KNIGHT CANCER RESEARCH BUILDING

LAND USE REVIEW #1 VS #2 COMPARISON DOCUMENT

LU 15-279775 DZM AD

MAY 02, 2016

ELEVATIONS

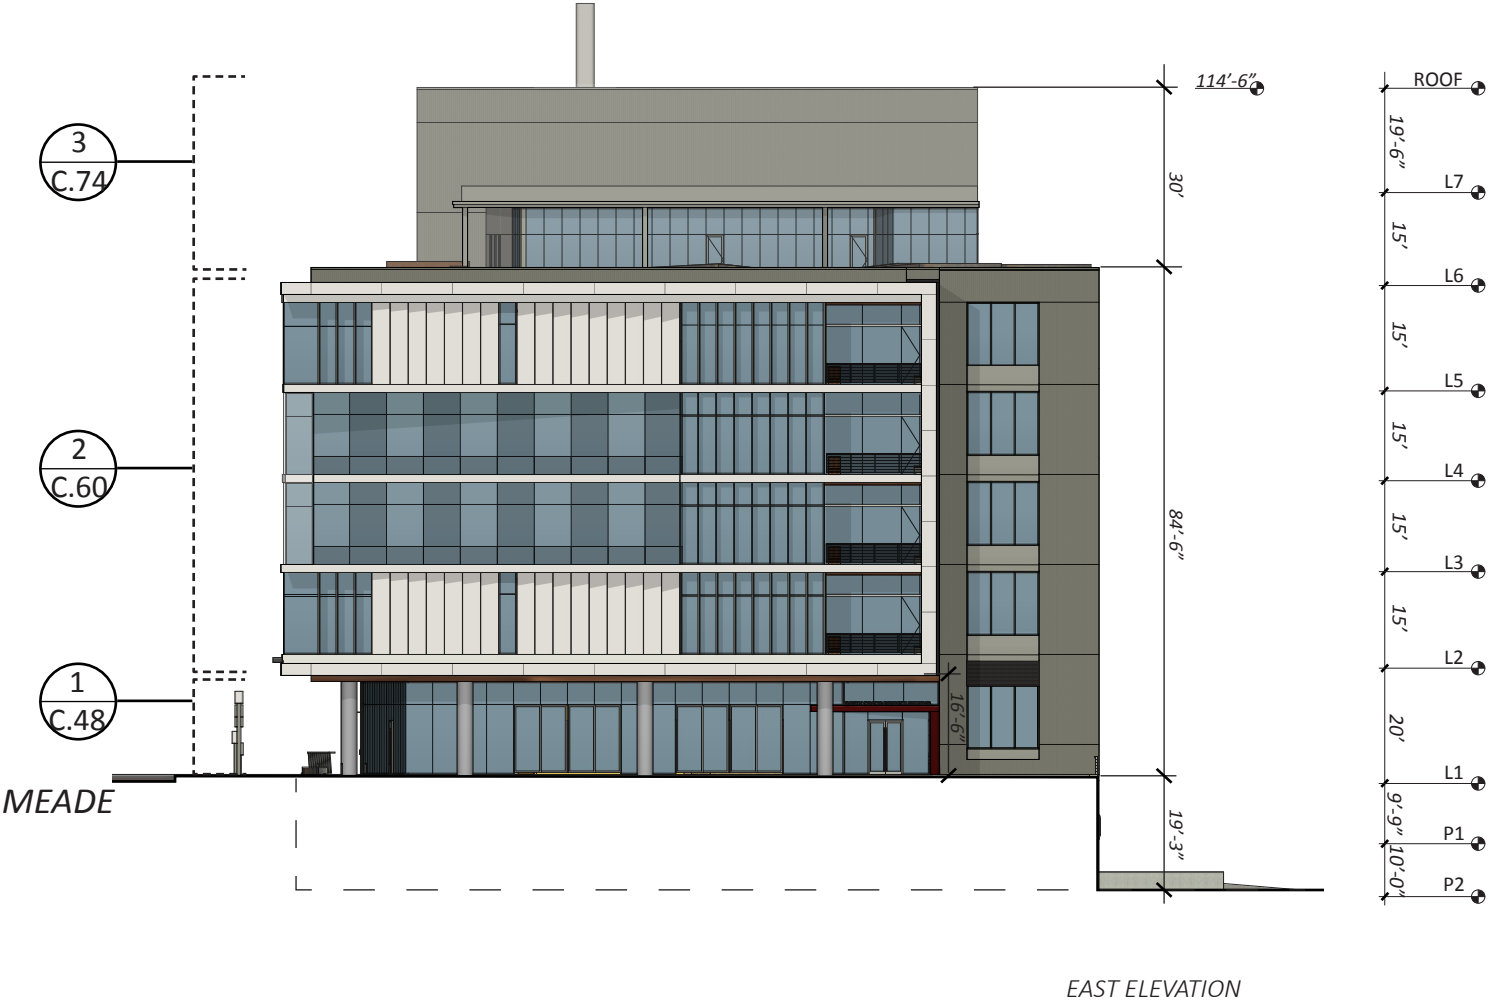
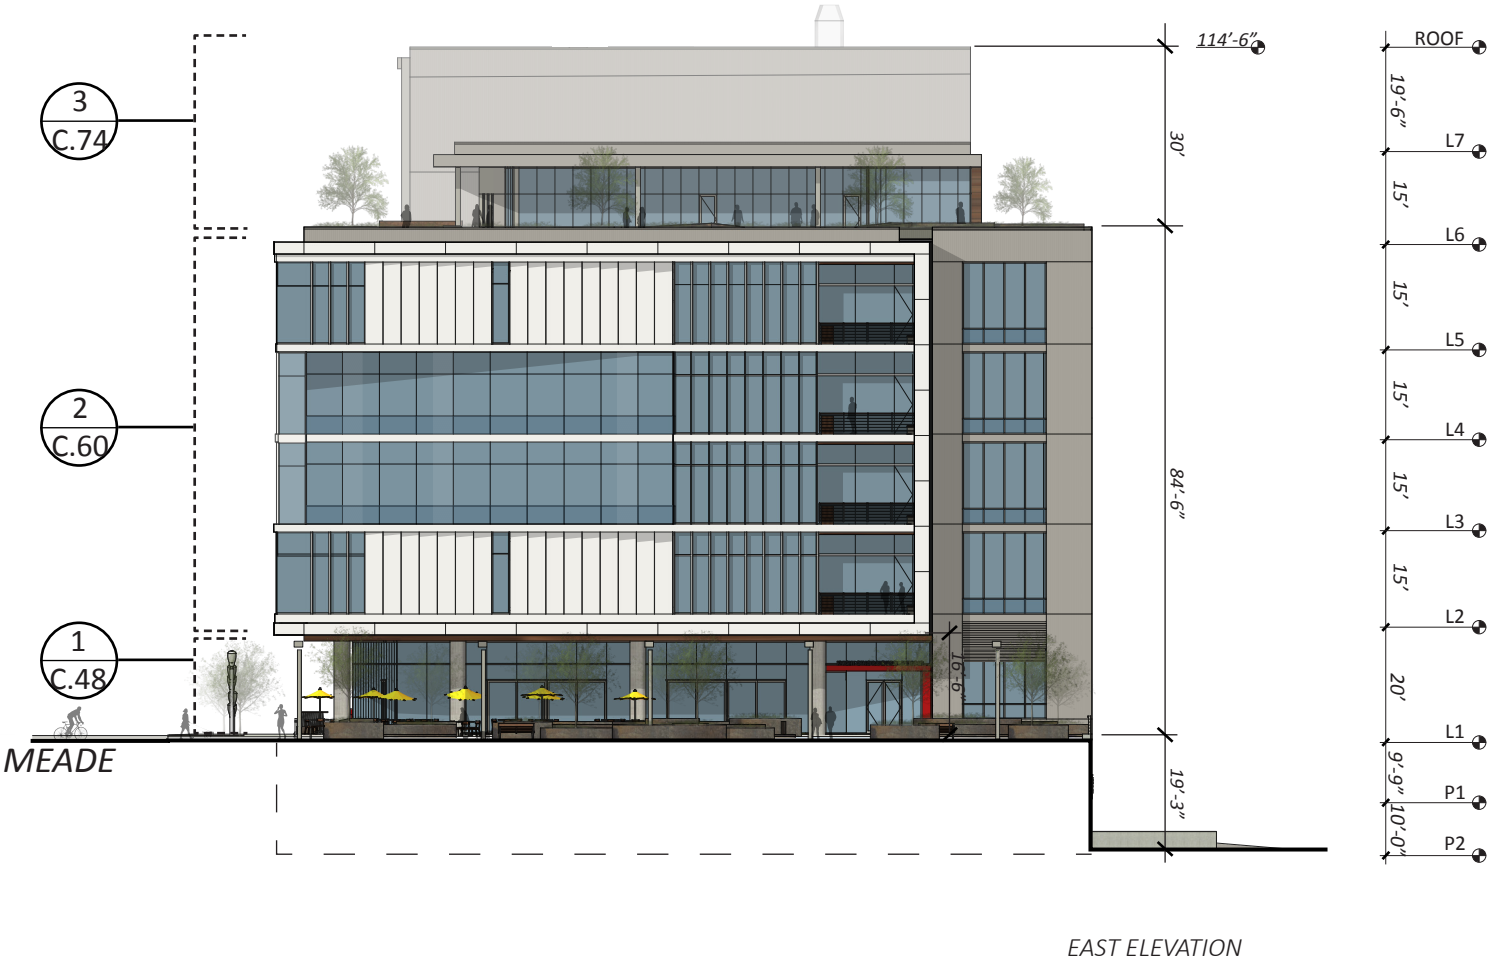
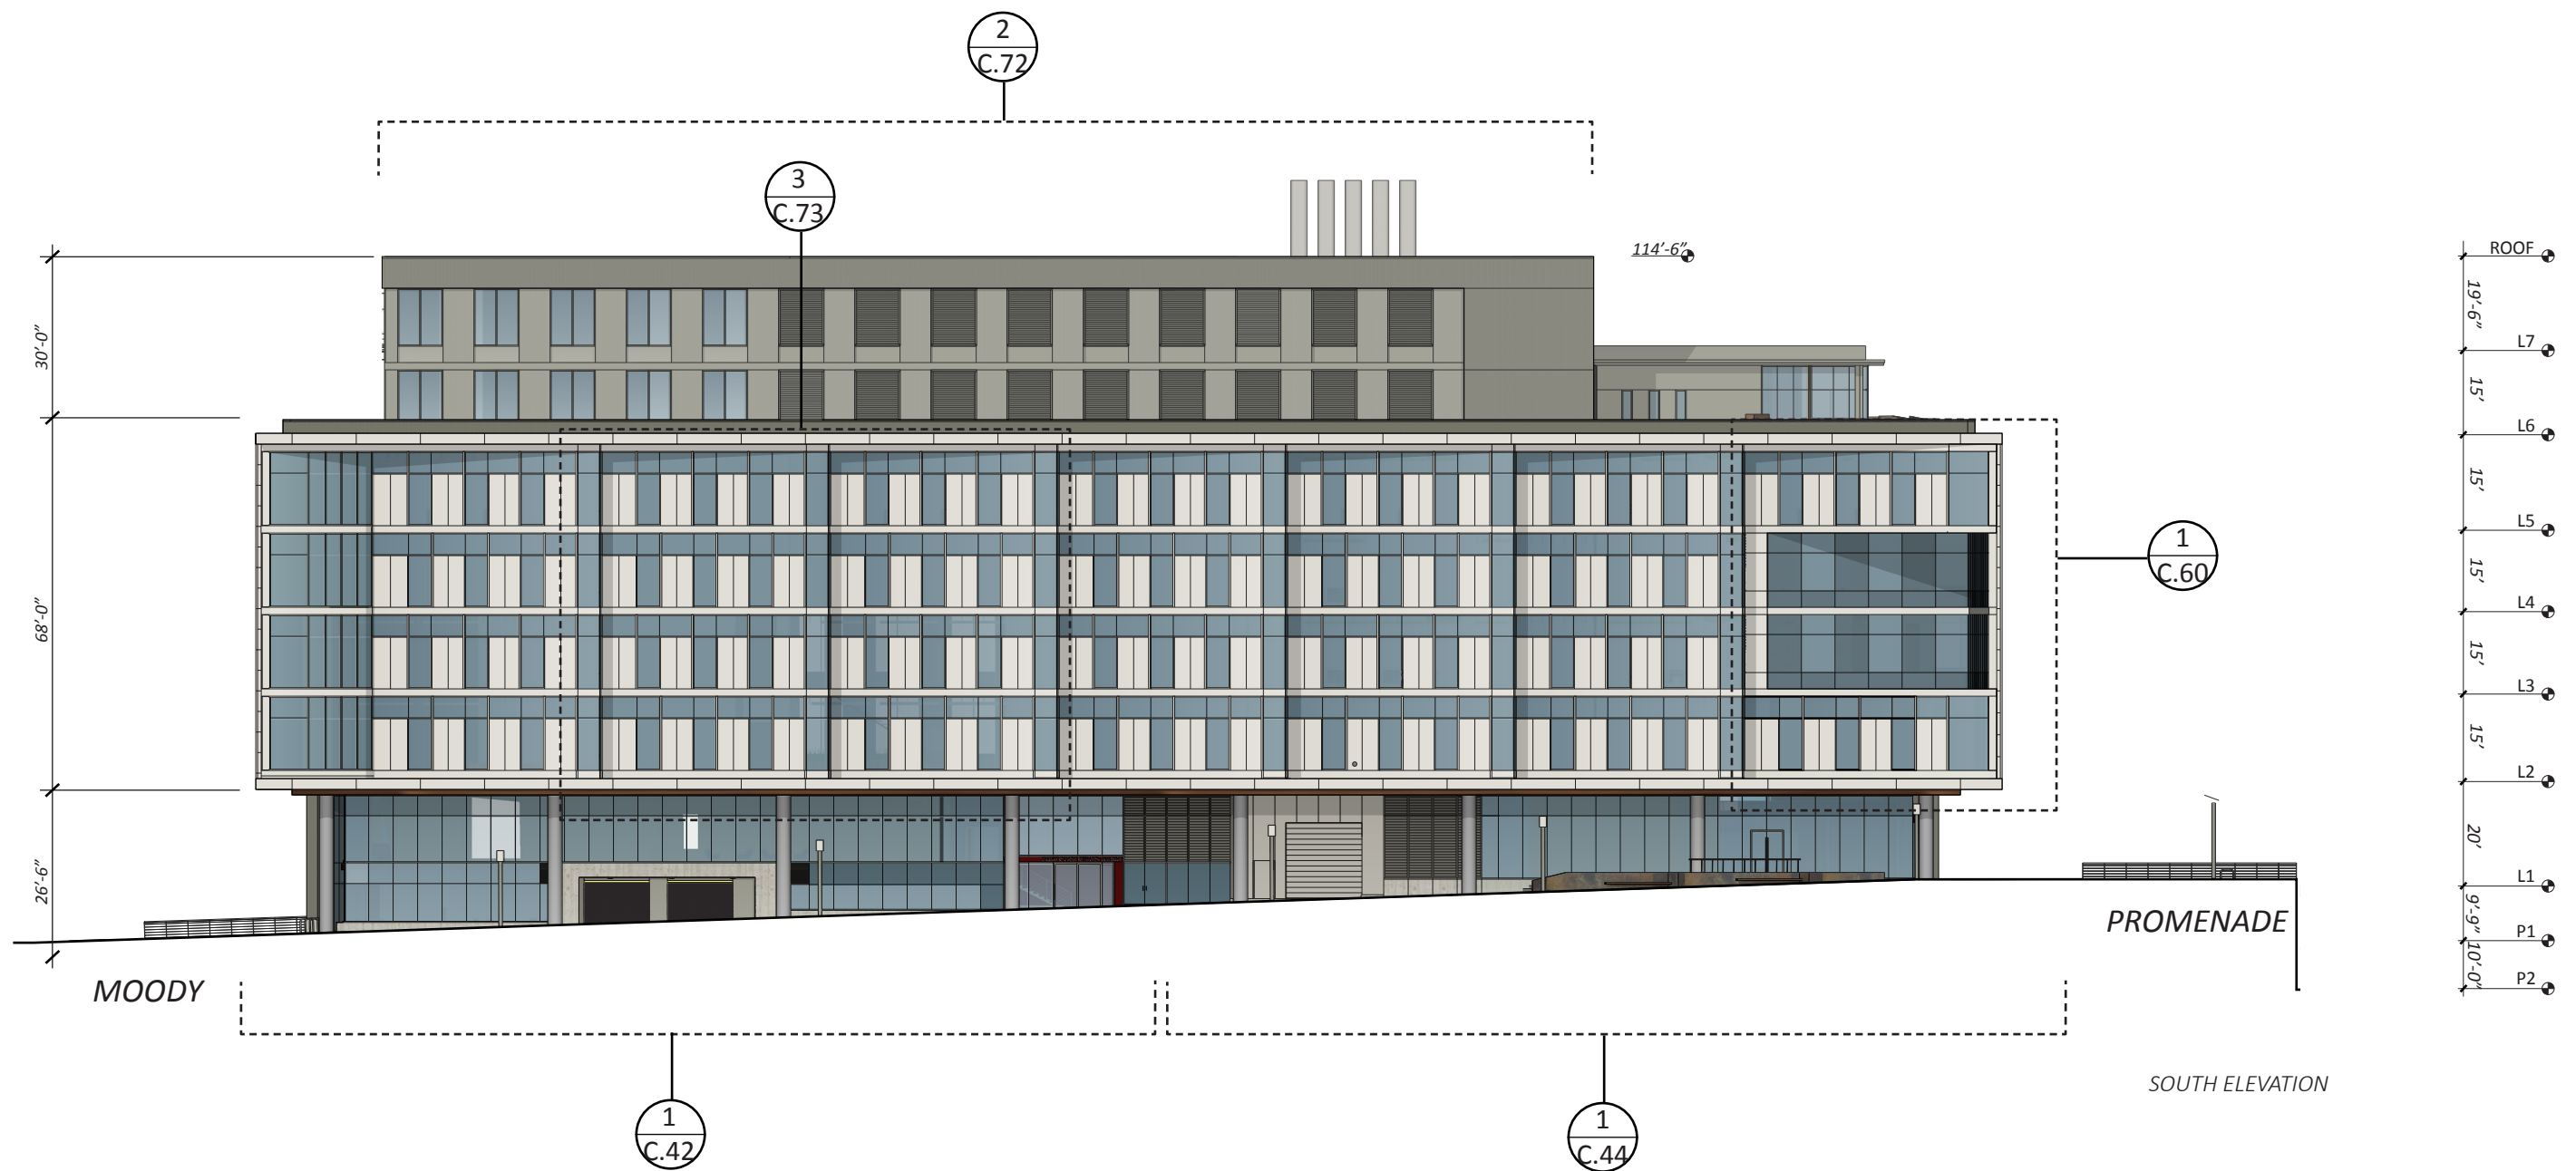
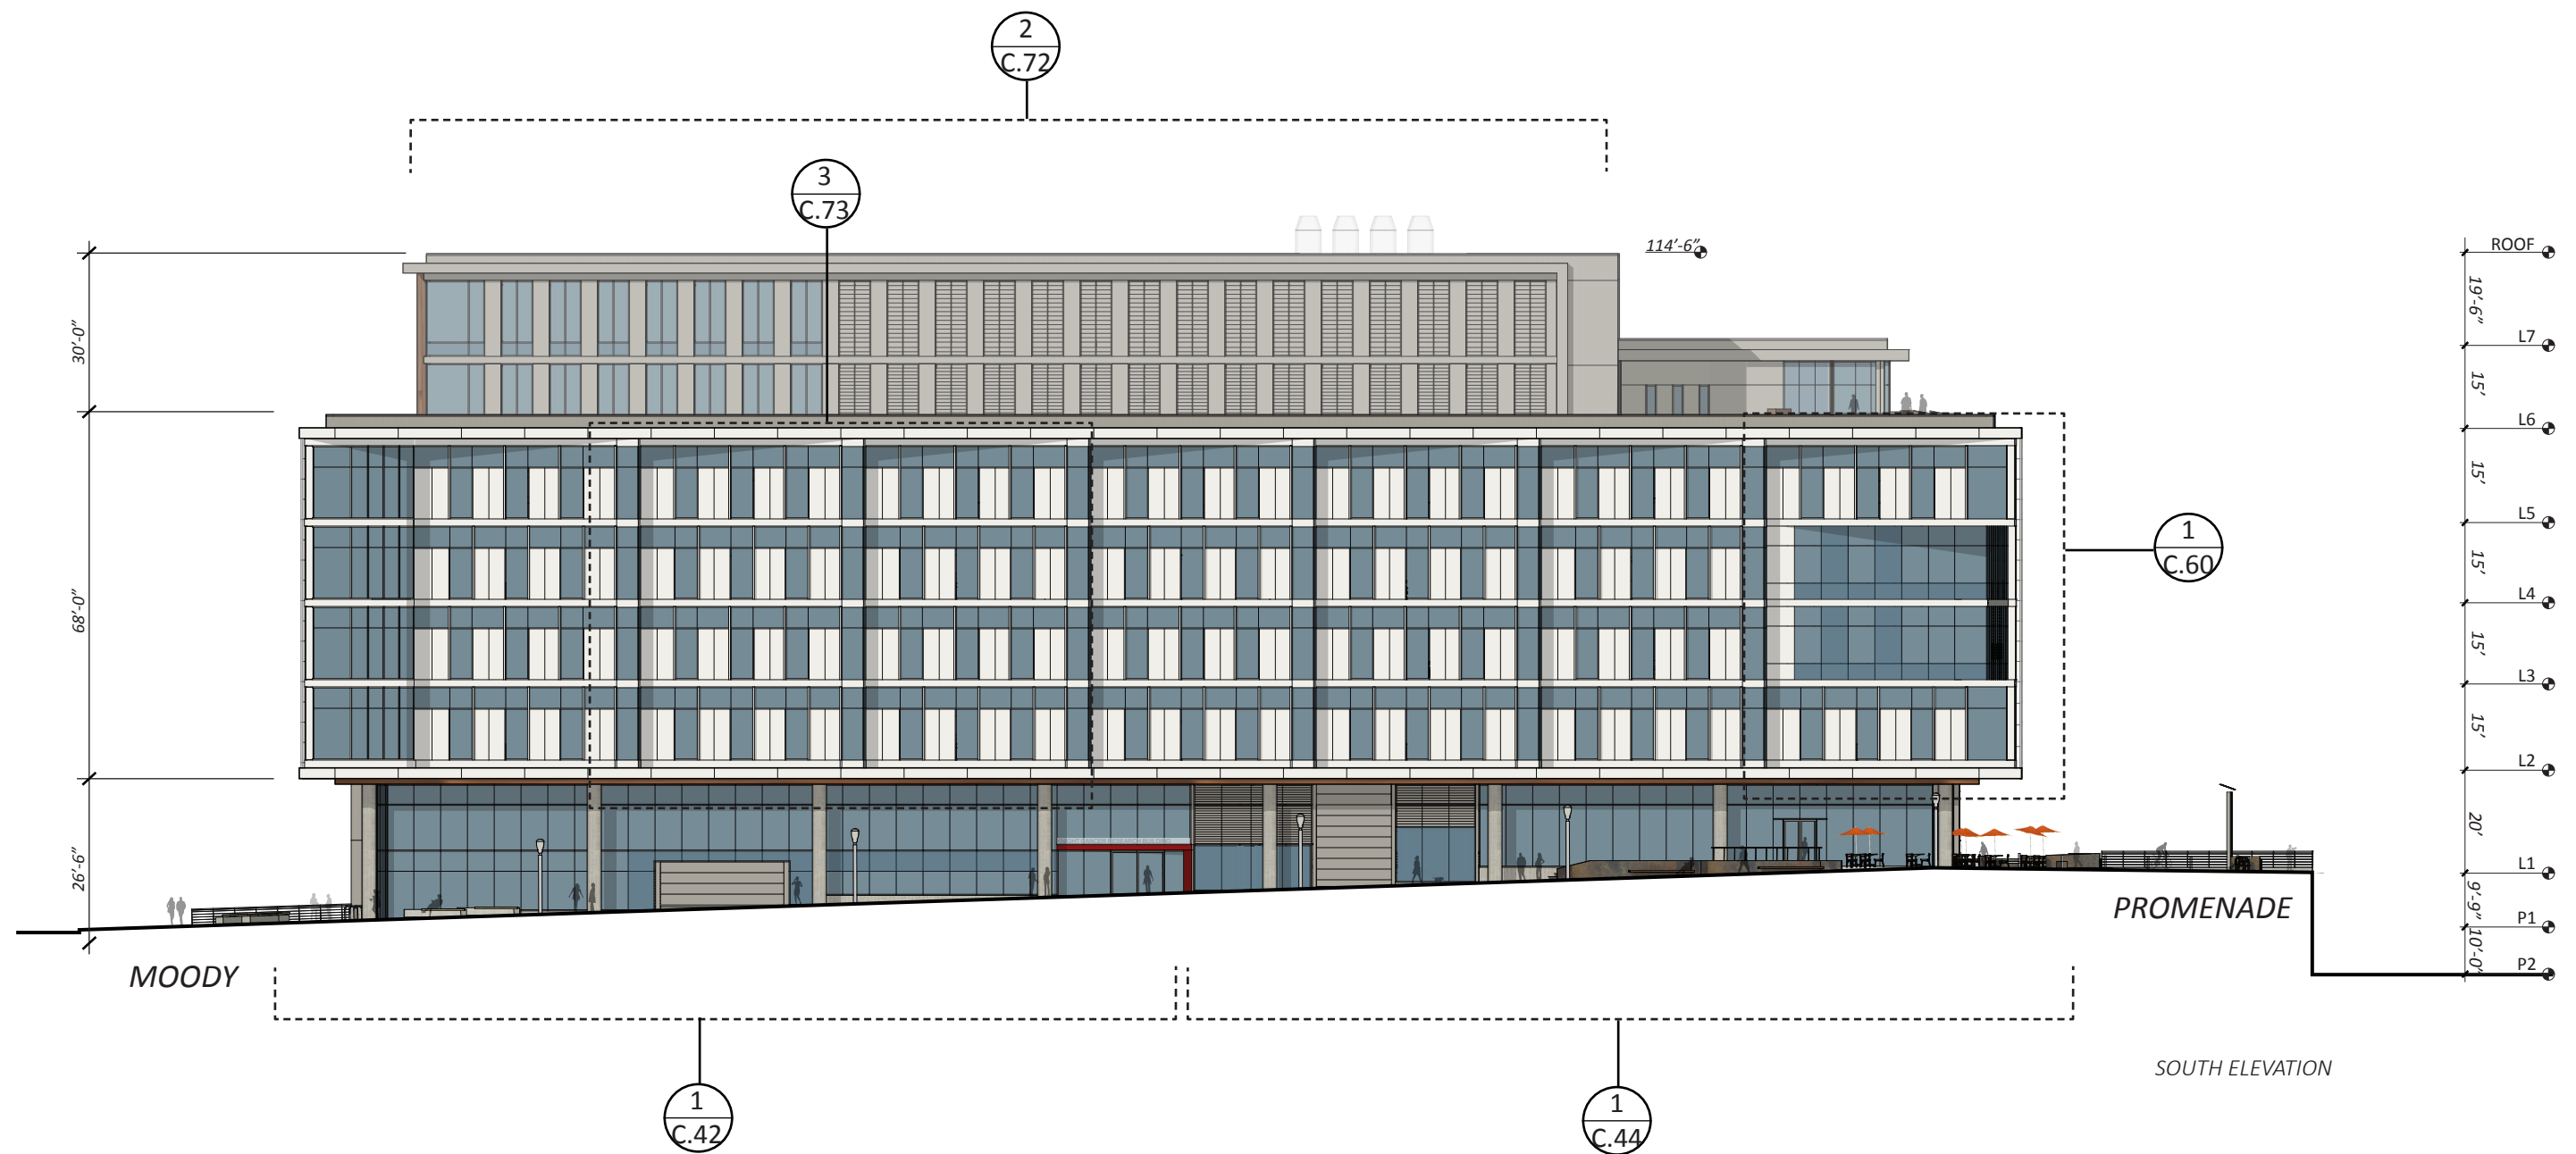
- ELIMINATED DARK METAL PANEL
- REPLACED PUNCHED WINDOWS AT THE 6TH AND 7TH FLOORS WITH CURTAINWALL (WEST AND SOUTH ELEVATION)
- REPLACED BOX RIB MP-2 AT THE 6TH AND 7TH FLOORS WITH COMPOSITE METAL PANEL (WEST AND SOUTH ELEVATION)
- REPLACED PUNCHED WINDOWS AT BOOKEND WITH CURTAIN WALL
- ADDED PUNCHED WINDOWS AT 6TH AND 7TH FLOORS ON THE NORTH FACE
- REPLACED COMPOSITE METAL PANEL WITH SPANDREL GLASS AT BOOKENDS
- ADDED COMPOSITE METAL PANEL BROW FOR ADMIN AND LOUNGE
- REDUCING WEIGHT OF THE TOP TWO FLOORS
- REDUCED HEIGHT OF EXHAUST STACKS
